**OICA PROPOSAL FOR A DRAFT ADDENDUM TO THE PROPOSAL
FOR DRAFT 01 SERIES OF AMENDMENTS TO REGULATION No. 107**
(M2 and M3 vehicles) **Document TRANS/WP29/GRSG/2003/5**

Figure B

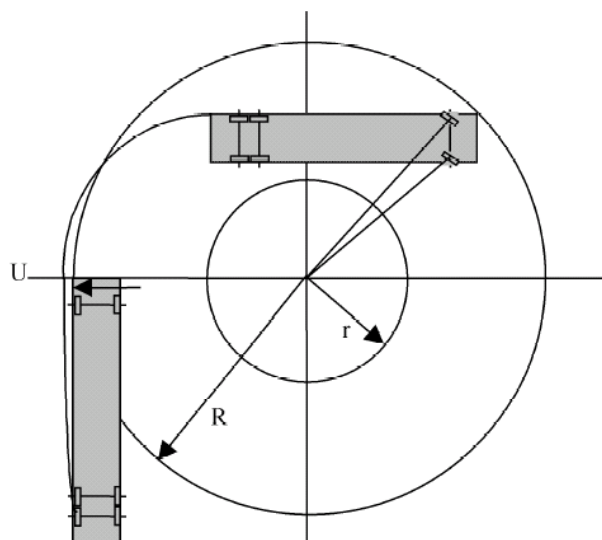
Replace figure B by the following:

R = 12.5 m

r = 5.3 m

U = maximum 0.6m

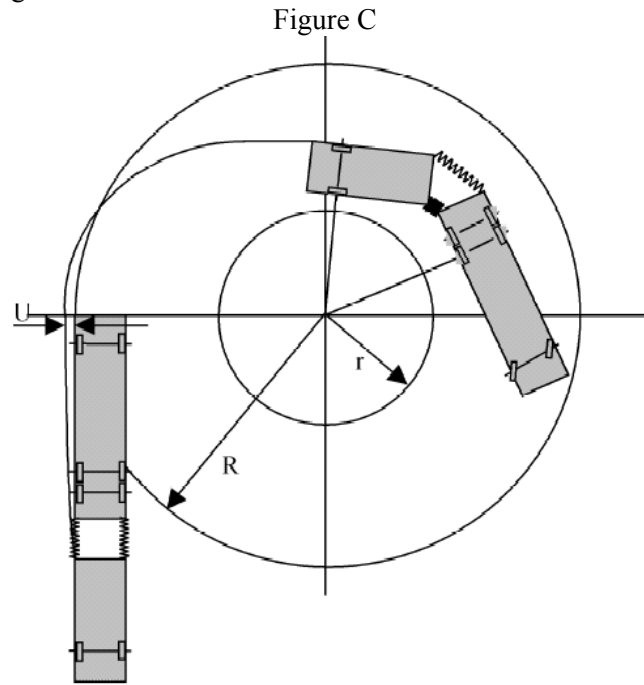
Replace figure C by the following:

$R = 12.5$ m

$r = 5.3$ m

$U =$ maximum 0.6m
